## COUNCIL ASSESSMENT REPORT

<b>Panel Reference</b>	PPSSNH-208
<b>DA Number</b>	DA92/21
<b>LGA</b>	North Sydney
<b>Proposed Development</b>	Demolition of existing buildings, excavation, and construction of a five storey shop top housing (mixed use) development with apartments on the upper levels, with commercial/retail tenancies below and basement parking.
<b>Street Address</b>	12-14 Waters Road, Neutral Bay
<b>Applicant/Owner</b>	Applicant: CE Waters Pty Ltd Owners: SP68360, SP75048, SP88483, Hari Om Investment Pty Ltd
<b>Date of DA lodgement</b>	12 April 2021
<b>Total number of Submissions</b>	• 12
<b>Number of Unique Objections</b>	• 12
<b>Recommendation</b>	<b>Approval</b>
<b>Regional Development Criteria (Schedule 7 of the SEPP (State and Regional Development) 2011)</b>	Capital Investment Value (CIV) of the original scheme exceeds \$30 Million
<b>List of all relevant s4.15(1)(a) matters</b>	<ul style="list-style-type: none"> <li>• SREP (Sydney Harbour Catchment) 2005</li> <li>• SEPP (Infrastructure) 2007</li> <li>• SEPP (State and Regional Development) 2011</li> <li>• SEPP No. 55 – Remediation of Land and draft Remediation SEPP</li> <li>• SEPP No.65 – Design Quality of Reside

**Figure 14: Proposed changes to roof top communal areas**

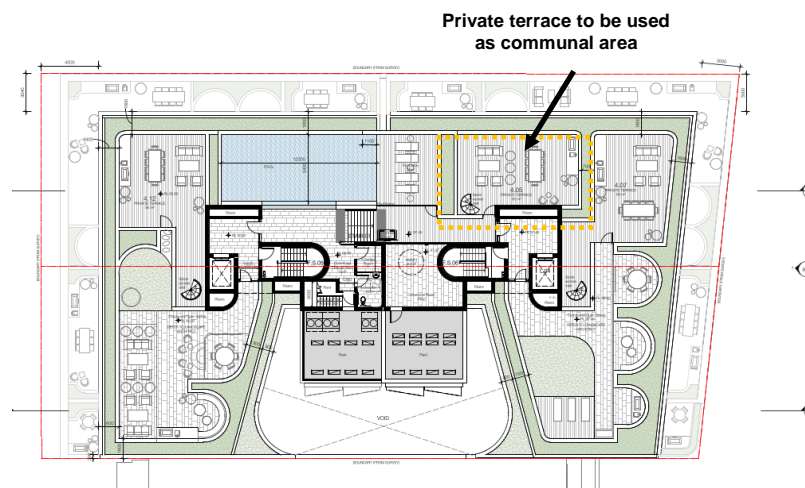
- *The pedestrian entrance off Waters Road should be re-designed to provide better access.*
- *The roof top communal rooms should be re-designed to allow better access to sunlight for these rooms.*

- *The northern private roof terraces should be for communal use.*

The applicant has simplified the northern elevation of the roof top communal rooms to allow additional daylight access to the communal areas.

In addition, the applicant has increased the size of the communal area around the proposed swimming pool in response to the DEP comments. It is considered that the northern side of the roof level is still dominated by two large private terraces.

It is recommended that the design of the roof level be modified with the deletion of the private terrace for unit 4.05 and the area be used as a communal space in order to ensure good amenity for the communal areas on the northern side of the building (**Condition AA1**).

**Figure 15: Proposed design modifications for central units**

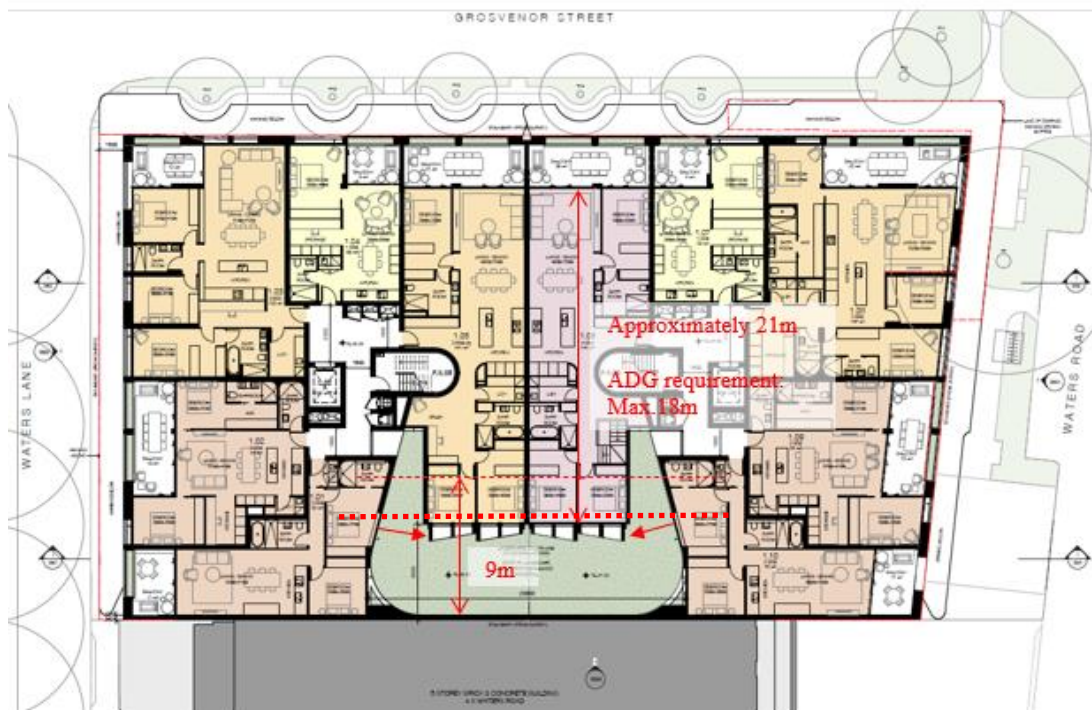
- *Height of the southern courtyard wall should be reduced to improve access to natural light.*
- *The size/length of the central north facing apartment should be reduced to improve ventilation.*

- Lightwell improvements
- The central north facing apartments have been reduced in length (depth) to improve ventilation

The concerns raised by the DEP are generally concurred with and echoed by Council's Senior Strategic Planner (Urban Design) as detailed later in this report. It is therefore recommended that the depth of the central units on Levels 3 and 4 (Units 3.04, 3.05, 4.04 and 4.05) be reduced to 18m as measured from the northern building line to provide additional building separation with a setback of 9m from the southern wall of the lightwell to maintain visual privacy, natural ventilation/air circulation and access to daylight within the lightwell. (**Condition AA2**).

The recommendation for the reduction in the depth of the central units (the elongated three (3) bedroom units orientated north-south) is supported. It is recommended that the depth of the middle units on Levels 3 and 4 (Units 3.04, 3.05, 4.04 and 4.05) be reduced to 18m as measured from the northern building line to provide additional building separation for these upper level units adjacent to the lightwell that is likely to enhance visual privacy, improve natural ventilation/air circulation and promote improved access to daylight arising from the lightwell as well as the lower level units on Levels 1 and 2 (**Condition AA2**).

**Figure 16: Proposed Development and the LEP Maximum Building Height**

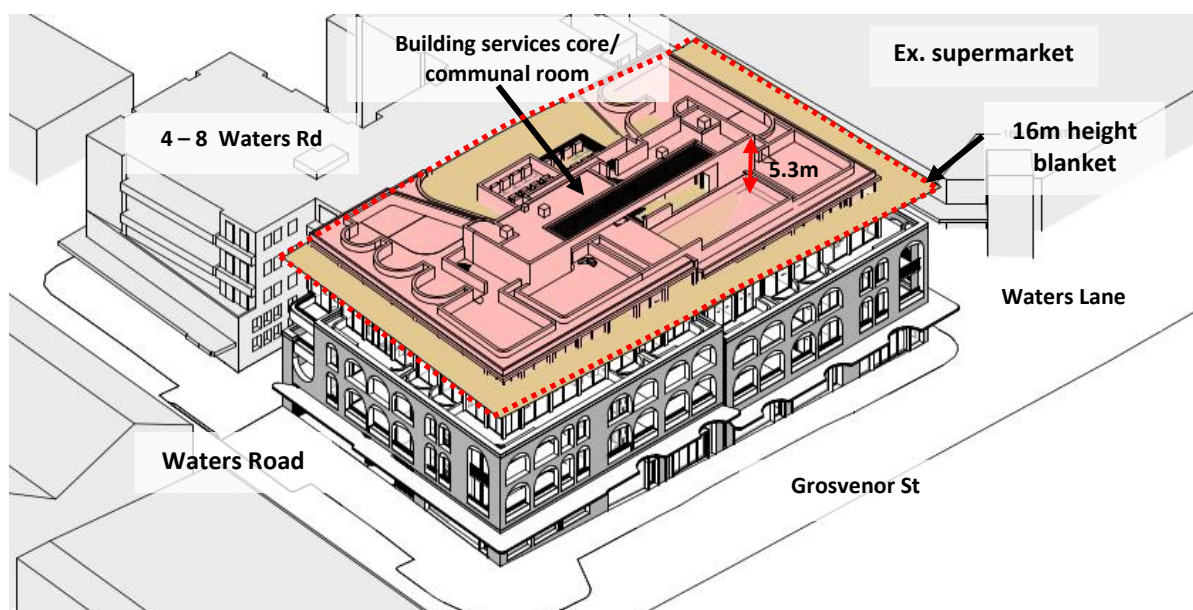
Clause 4.3(2) of the LEP 2013 and the LEP building height map specify a maximum building height of 16m for the subject site. The building elements in breach of the LEP building height limit primarily relate to the upper section of Level 5, the roof slab including planters, a communal swimming pool, communal/private terraces and a structure housing the building services cores (2 x lift overruns/fore stairs and a 25sqm communal room). The building services and communal room structure is located at the centre of the roof level with the top of this structure reaching a maximum height of 21.3m with breaches the LEP maximum building height limit by a maximum of 5.3m. The non-complying building elements are shown in red in **Figure 16** below.

**Figure 19: Views from Level 5 window on the northern elevation**

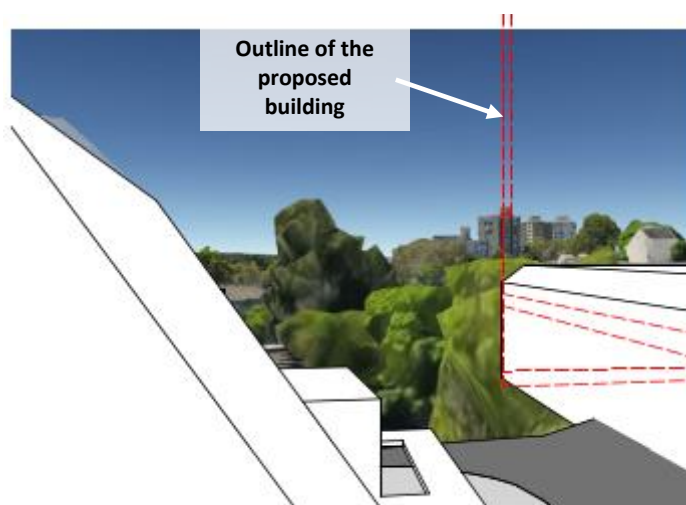
The views from the windows on the northern elevation of the top level (Level 5) apartment located at the north-eastern corner of Nos.4-8 Waters Road contains nearby buildings and vegetation as well as the skyline towards the north-east as illustrated in **Figure 19**. It is noted that these are secondary windows on the northern wall of the living room. The living room has a main full height glazed doors on the eastern wall to a balcony with views of nearby buildings/vegetation and the eastern skyline.

It is also noted that the views obstructed by the proposed development would be caused by complying building elements under the maximum building height limit as seen from the secondary living room windows. The proposal would have impacts on the views/outlook towards the east as seen from the main full height glazed doors and the balcony on the eastern elevation of the building.

**Figure 20: View analysis for a terrace on the top level (Level 5) at north-western corner of Nos.4-8 Waters Road (Looking north/north-east)**

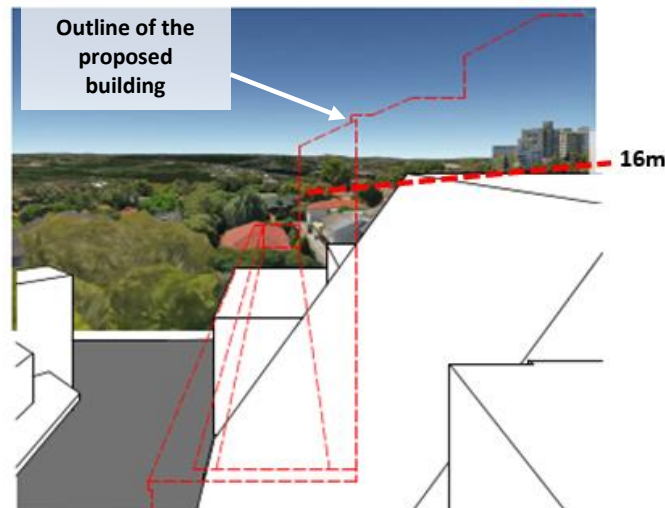
The views from the terrace of the top level (Level 5) apartment located at the north-western corner of Nos.4-8 Waters Road contains nearby buildings and vegetation as well as a wide district and skyline views towards the north, north-east and north-west as illustrated in Figures 20 and 21.

The proposed development would cause partial obstruction of the skyline view to the north-east, however, the district and skyline views towards the north and north-west as seen from the terrace in Figure 21 would be retained.

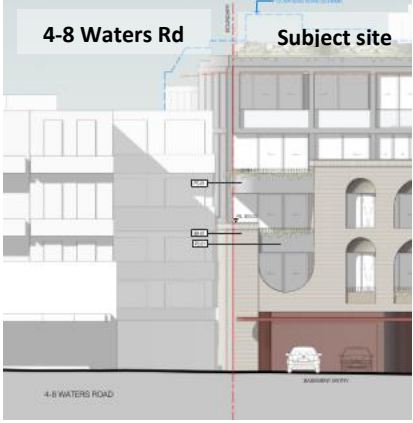
<b>Setbacks – Side &amp; Rear</b>	(Acceptable on merit)	<p>The applicant has proposed a transition podium height from 2 storey on the southern side to a three (3) storey podium height further to the north (front) of the building. The proposal is considered to acceptable as the design respects the two storey podium height on the eastern side of the adjoining mixed use building to the south (Nos.4-8 Waters Road).</p>
